CERTIFICATE OF APPROPRIATENESS

Property: 511 Arlington Street, Lot 10, Block 288, Houston Heights Subdivision. The property includes a historic 1,158 square foot, one-story wood frame single-family residence and a detached garage situated on a 6,600 square foot (50' x 132') interior lot.

Proposal: Alteration – *Windows Revision*

WINDOW REFERENCE KEY

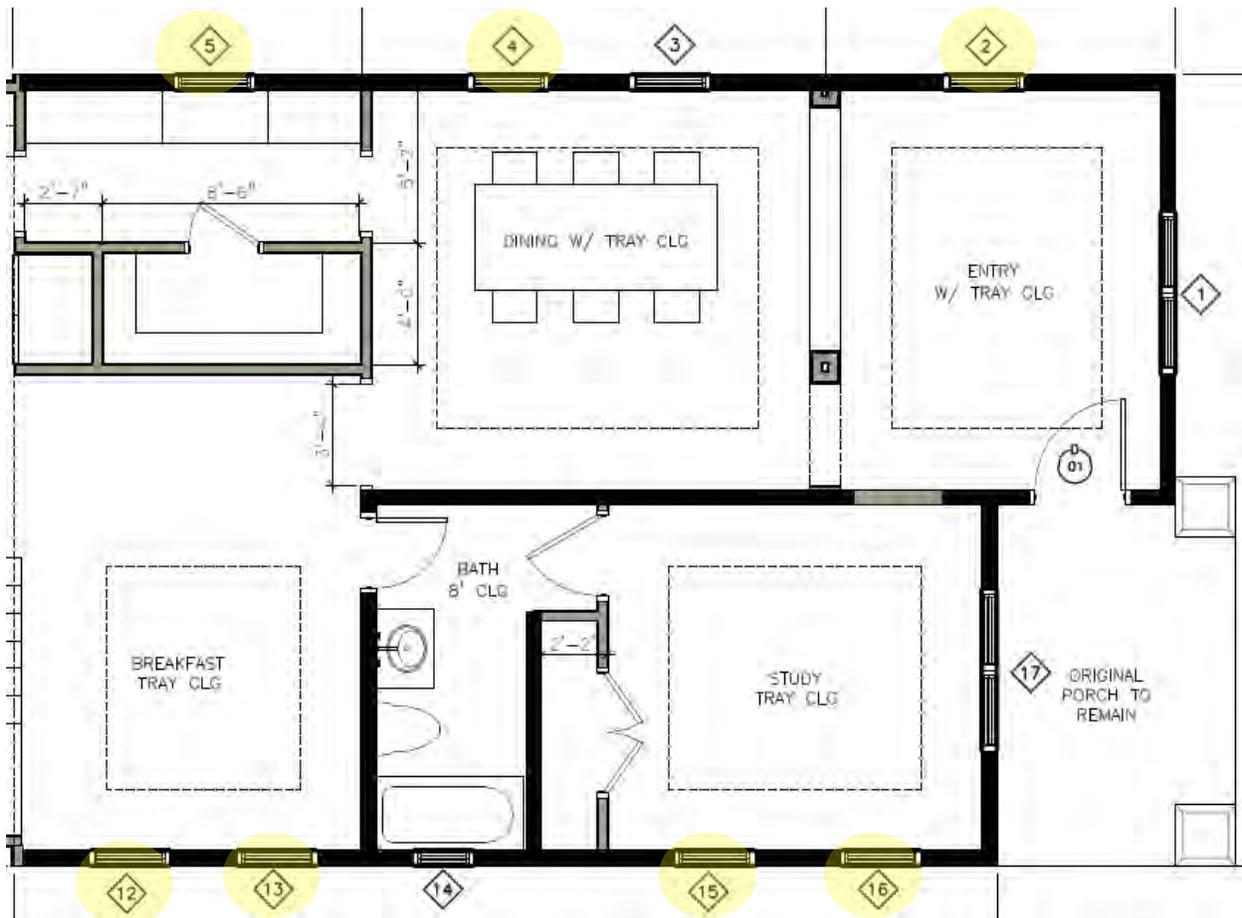
The applicant has since started construction and discovered damage to windows 7 of these windows which was not evident previously. They are now requesting approval to replace windows 2, 4, 5, 12, 13, 15, and 16 asserting that they are damaged beyond reasonable repair.

Staff and the City’s Structural Inspector performed multiple site visits to this property and found that the jambs and sills and the lower sashes of the windows have sustained significant damage. Staff and the inspector also found that all of the upper sashes are salvageable.

WINDOWS PROPOSED TO BE REPLACED ARE HIGHLIGHTED

6 of the existing windows feature a 2-over-2 divided lite configuration. Window-2 features a 2-over-1 lite pattern.

Recommendation: **Approval with conditions: The upper sashes for 2, 4, 5, 13, 15, & 16 be repaired and retained. The deteriorated jambs, sills, and lower sashes can be repaired or replaced with salvaged sashes.**

WINDOW 2

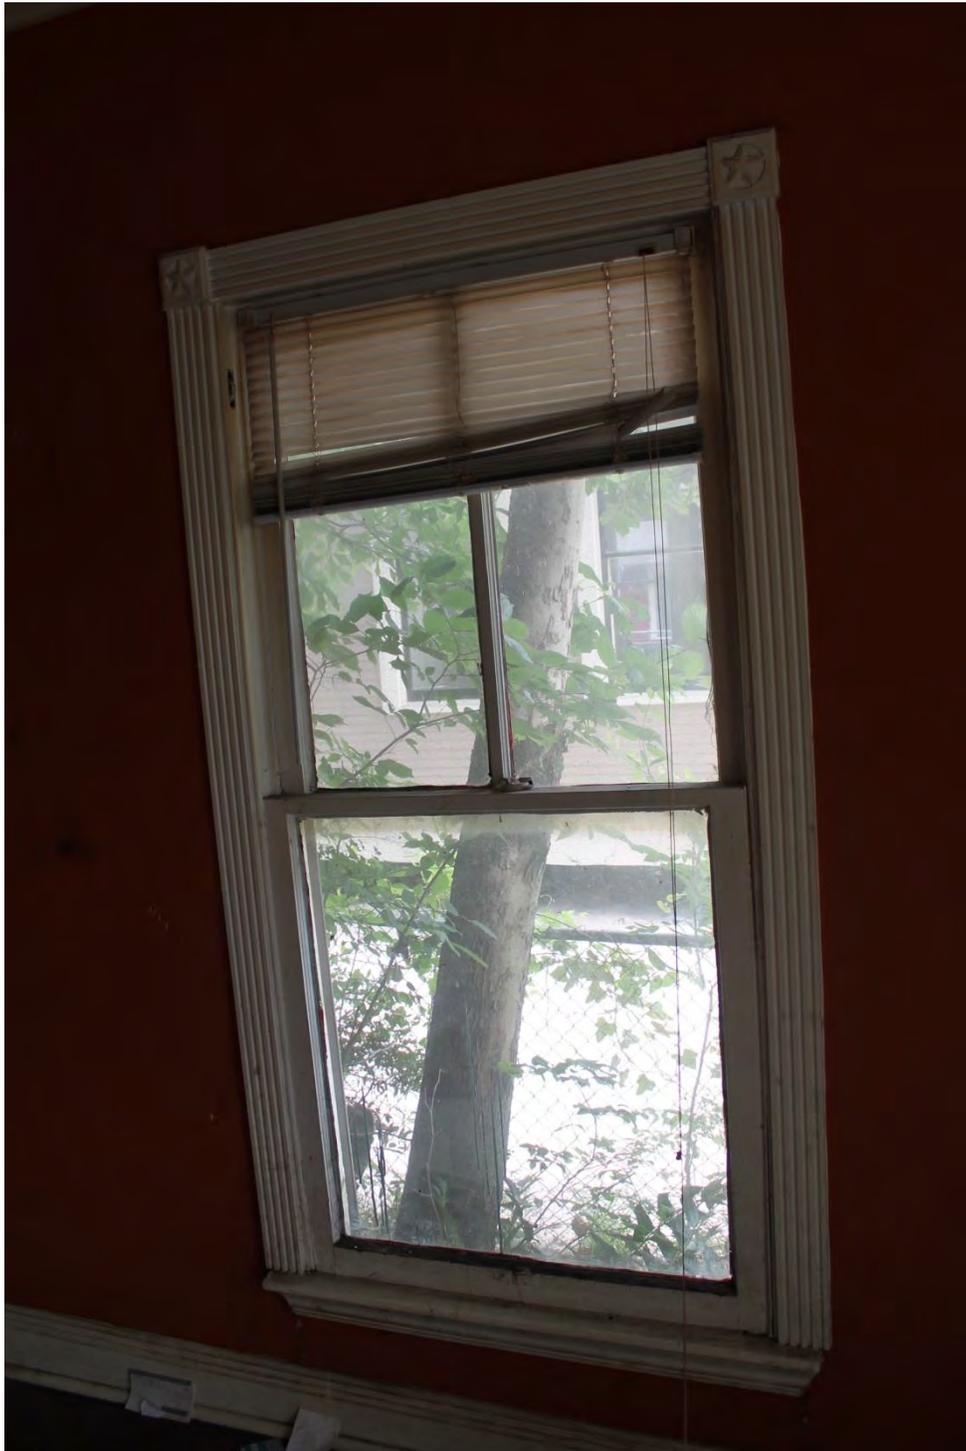
Staff's finds that historic windows consist of individual components that can be repaired or replaced while maintaining the remaining functioning components of the historic windows. Windows 2, 4, 5, 12, 13, 15, and 16 can have their damaged sills and jambs replaced with matching materials while the salvageable historic sashes can be maintained. In addition, the window sashes can have damaged muntins and rails replaced with in kind material while retaining the rest of the historic sash.

PROPOSED REPLACEMENT

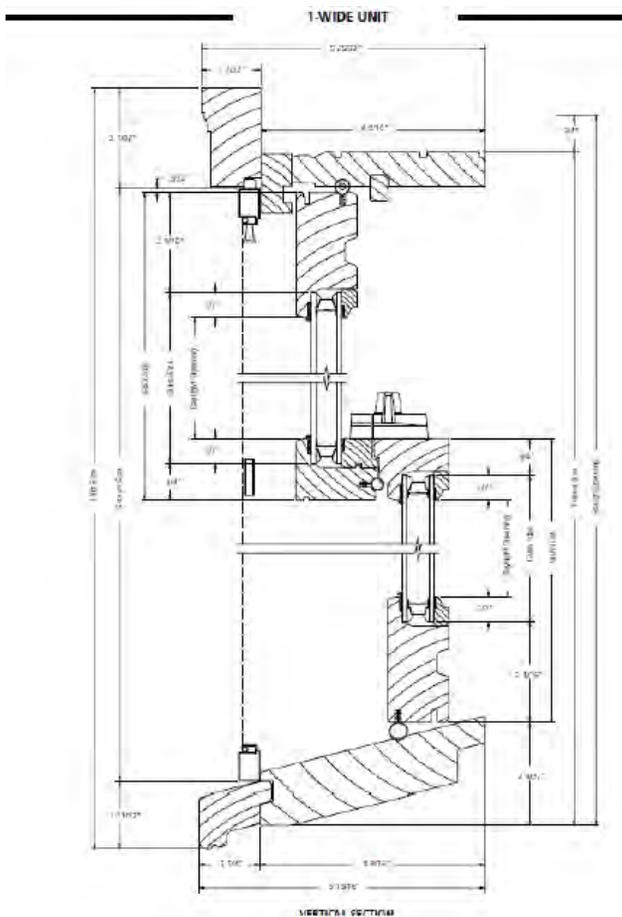
<i>The historic 2-over-2 windows represent a significant stylistic feature and are examples of skilled craftsmanship that cannot be replicated with the proposed sash pack replacements. Although the existing windows have deteriorated, their composition of individual components allows for their repair by replacing the damaged sill, jamb, and sash components for each window.</i> |

<i>The removal of original 2-over-2 wood windows constitutes loss of significant historic material and is inappropriate. Although, the existing windows have deteriorated, rebuilding these windows using existing sashes and salvaged components would preserve the character of historic windows, which cannot be replicated by new 1-over-1 sash pack windows.</i> |

The applicant proposes to replace these windows with new 1-over-1 sash pack windows.
